WELL 15 PFAS TREATMENT FACILITY

Change Order No. CO 7

Change Order to Public Works Contract Justification and Assessment

Contract 9342 - CHANGE ORDER REQUEST #7 - WELL 15 PFAS Treatment Facility

PROJECT NUMBER	60686092
SHEET TITLE	HVAC FIRST FLOOR PLAN
DWG NUMBER	10-H-01
SHT NUMBER	47 OF 55

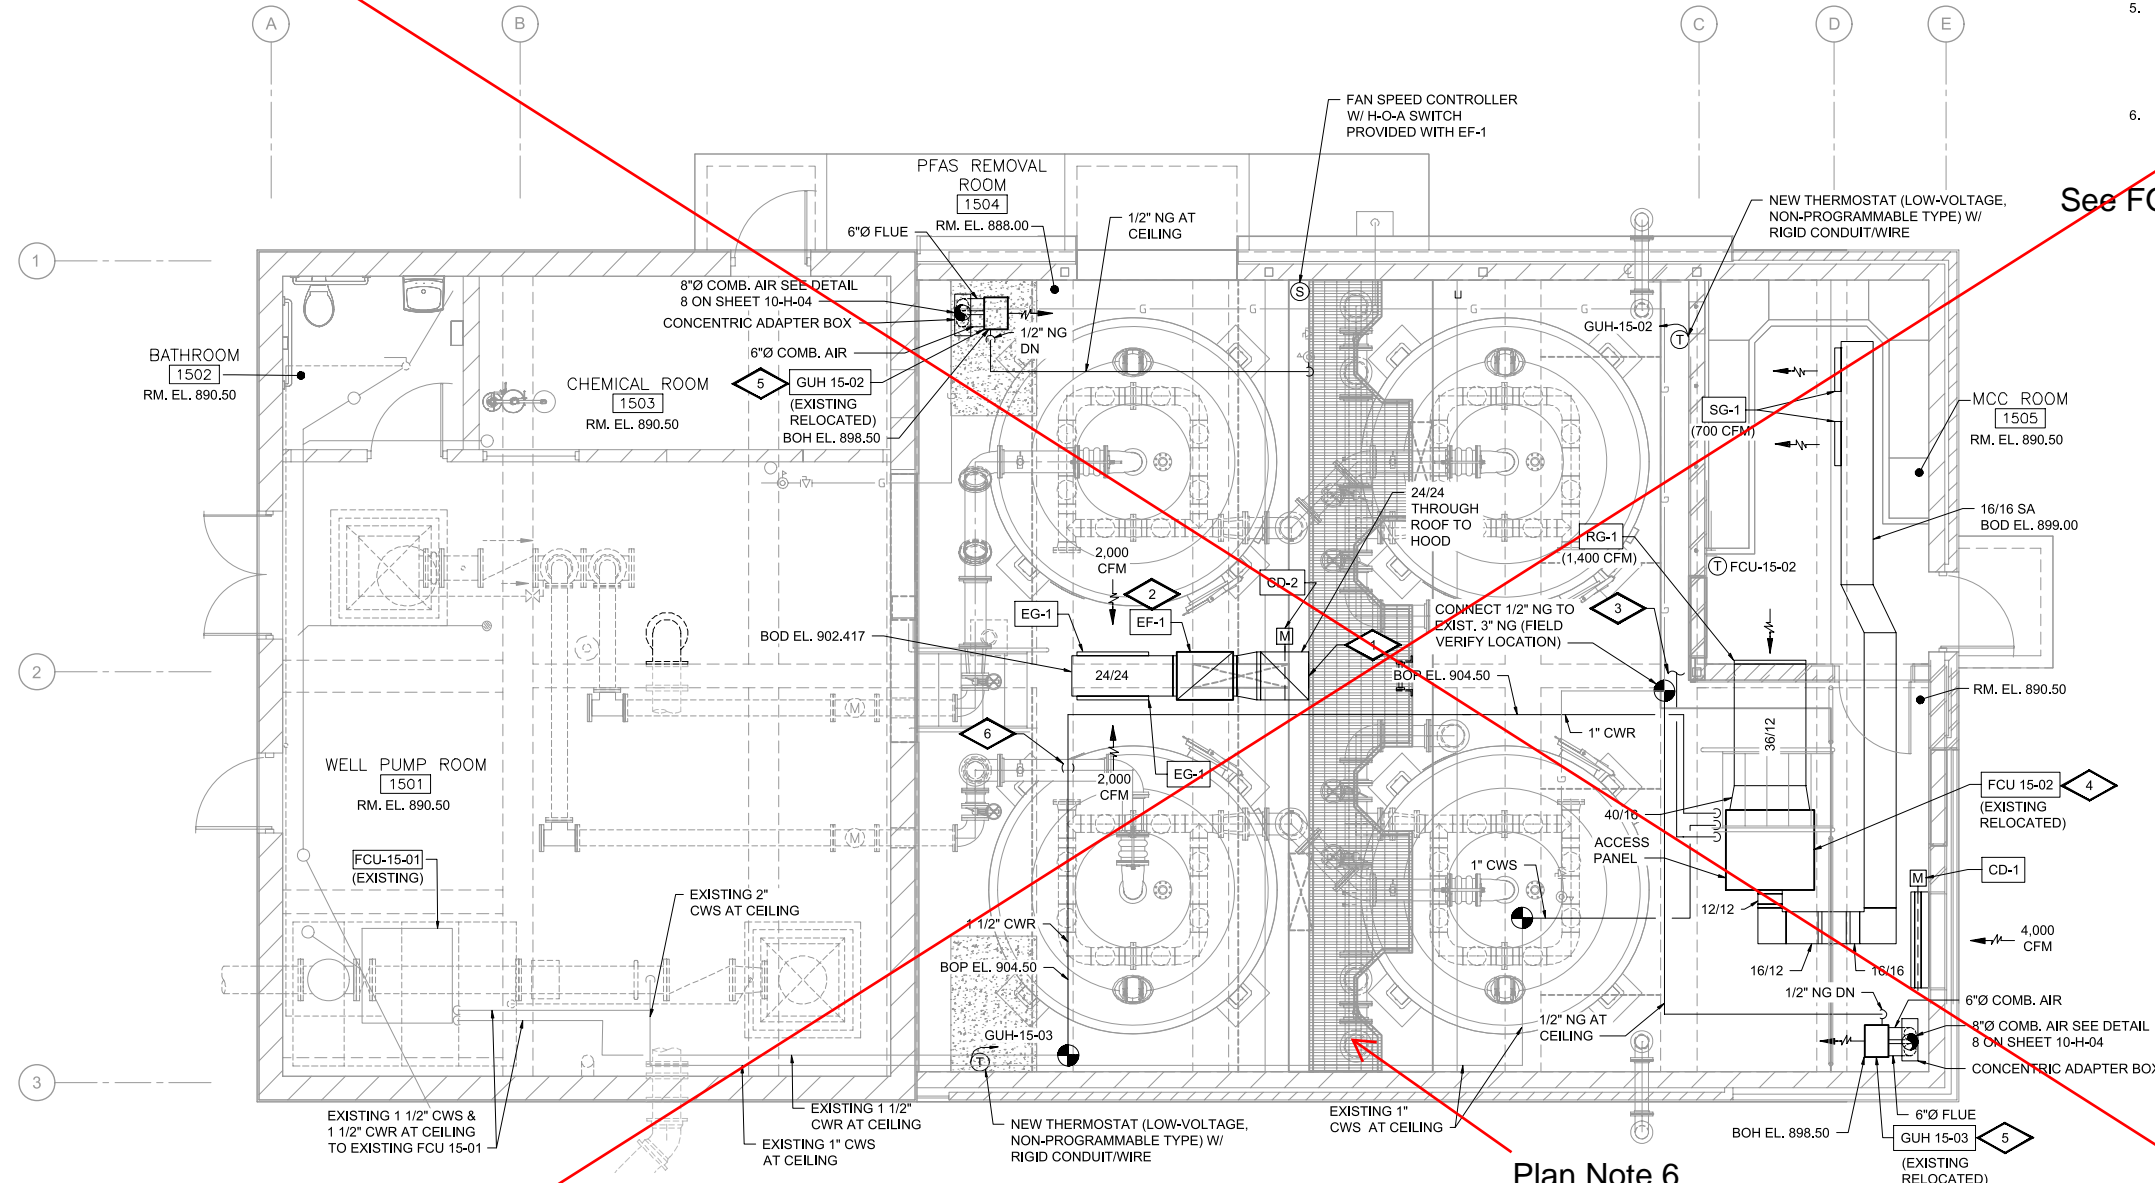
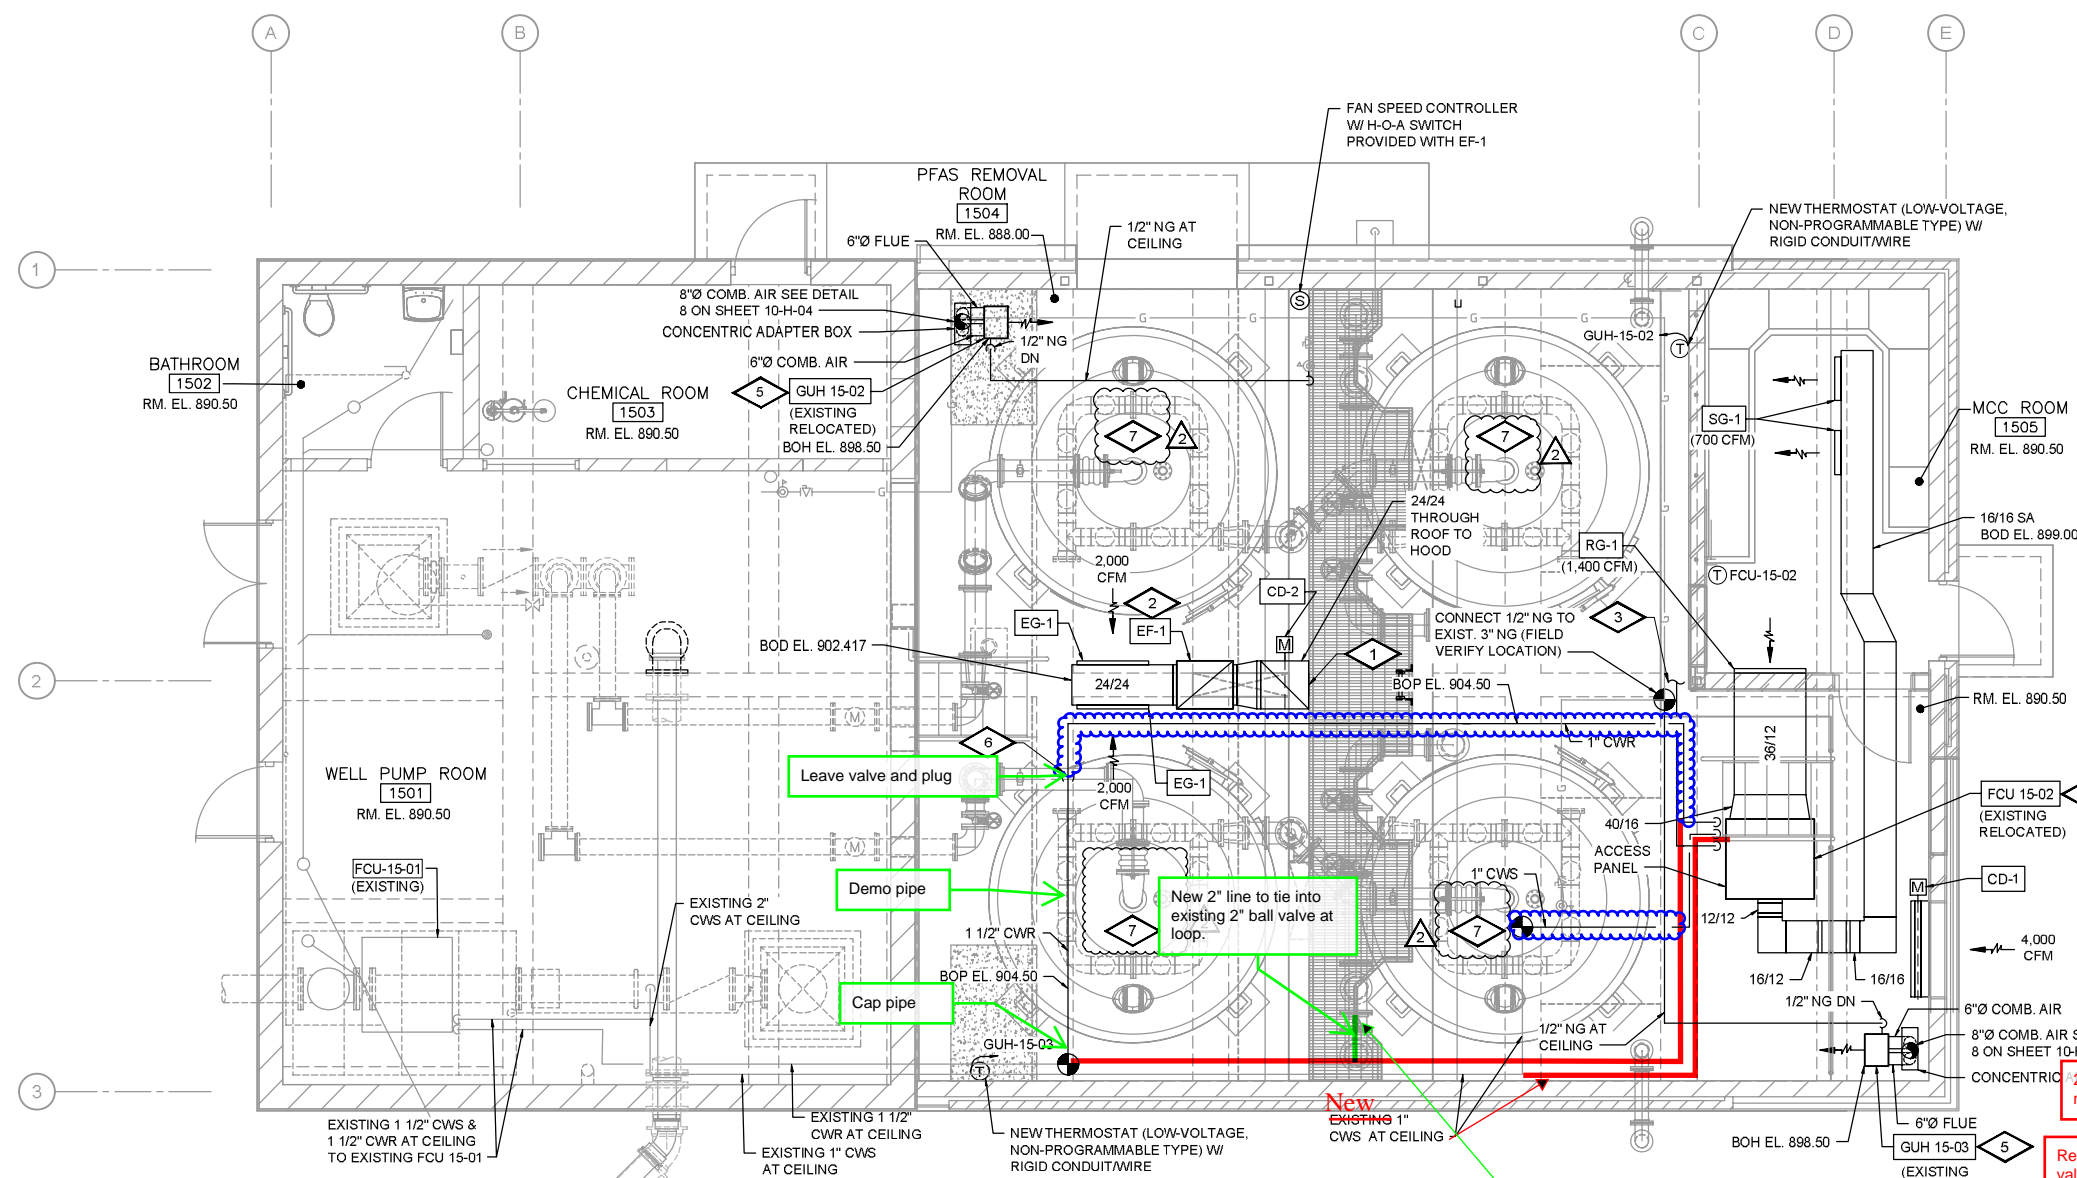
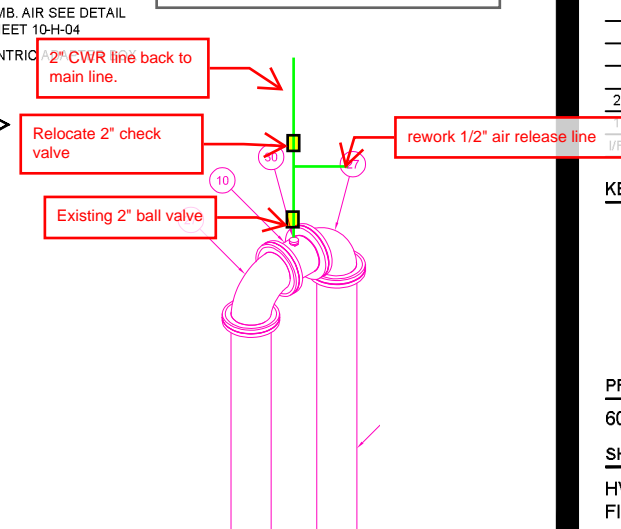
This change order is for the labor, material & equipment to reroute the 1-1/2" CWR termination at GAC Tank 2 to the pipe loop as shown on the attached revised Sheet 10-H-01. The new line will be insulated. Additionally, one (1) balancing valve will be installed at the discharge of each FCU to allow for balancing. Three (3) existing ball valves within the existing CWS/R line will be replaced to ensure proper isolation & balancing of the system. The proposal does not include any coatings or patching.

1. Add balance valve to water supply for FCU-1 (existing) and add to test and balance scope for project to water test for FCU-1 and FCU-2.
2. FCU water recycle pipe move discharge connection at pipe prior to GAC Tank #2 and discharge into effluent loop after IX Tank #2. Provide new tap. Cap existing tap.

See FO17 for update to plan note 6

Plan Note 6 move here

Pipe Loop FCU Tie-In Detail

Plan Note 6 move here
